P−17427
X2271

PARTY'S NAME	AKASH ENTERPRISES, PUNE
PARTY'S DRAWING No.	AS PER DRAWING
ALLOY & TEMPER	6063 T6
DESCRIPTION	HEAT SINK SECTION

DRAWING No.	SECTION No.
P−17427	−
X2271	X2271(ISSUE−3)

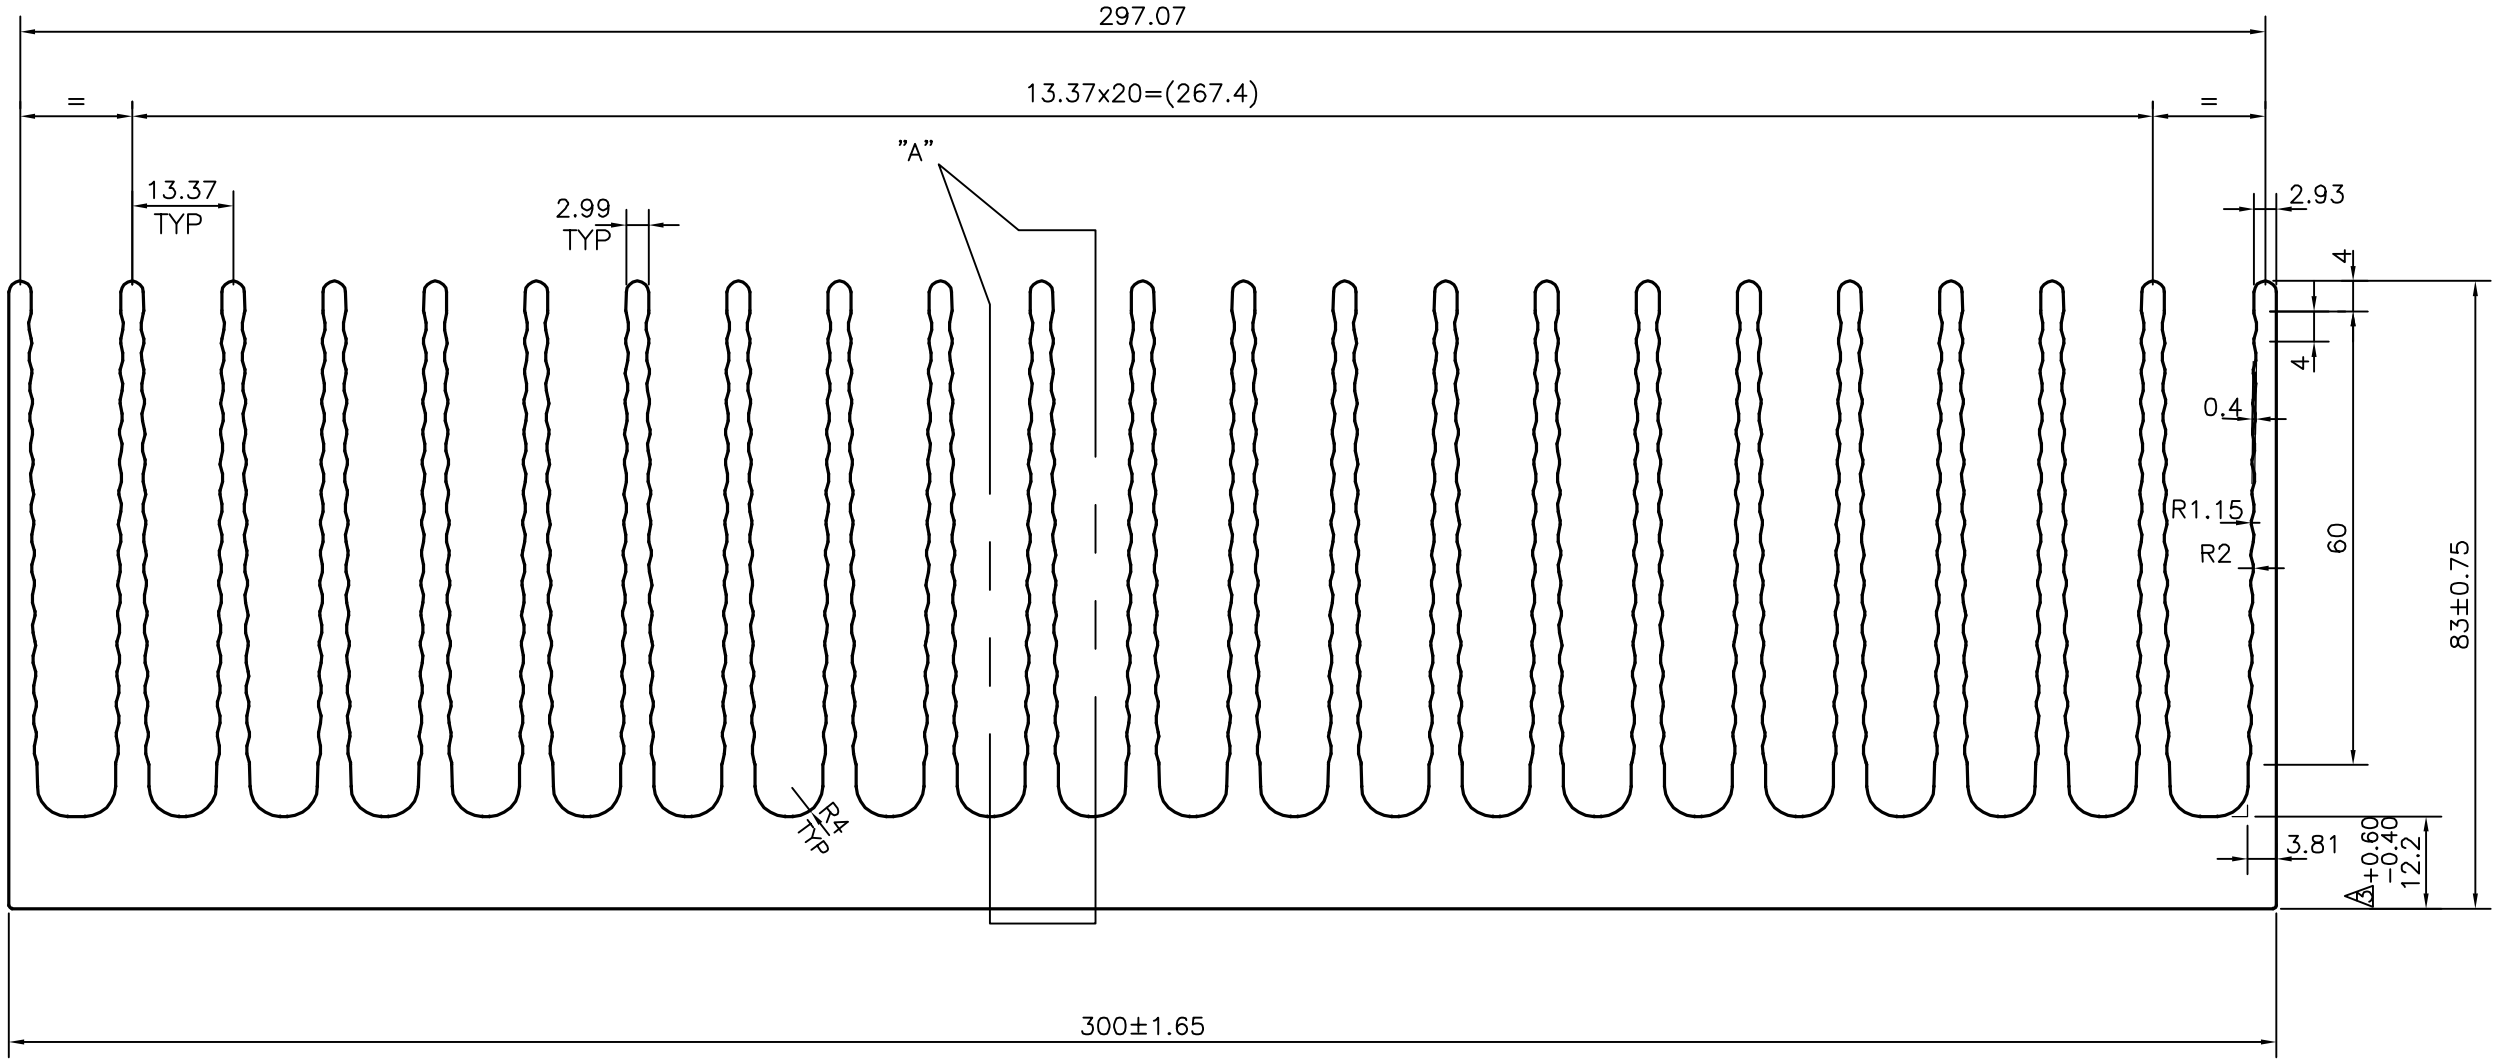
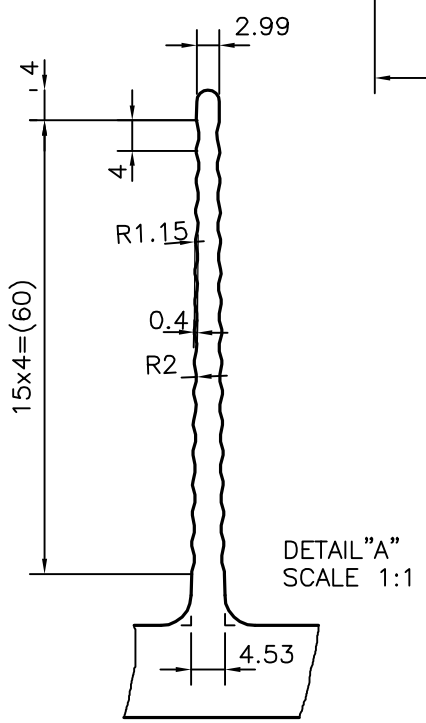
ISSUE− 3

TOLERANCE CHANGED ON $12.2^{\pm 0.50}$ TO $12.2^{+0.60}_{-0.40}$

AVERAGE WEIGHT:−24.818 kg/m TO 25.351 kg/m

ISSUE− 2

DIMENSION CHANGED FROM 12.0 mm TO 12.2 mm & TOLERANCE ADDED ON $12.2^{\pm 0.50}$

WEIGHT ALSO CHANGED FROM 24.924 TO 25.031 kg/m
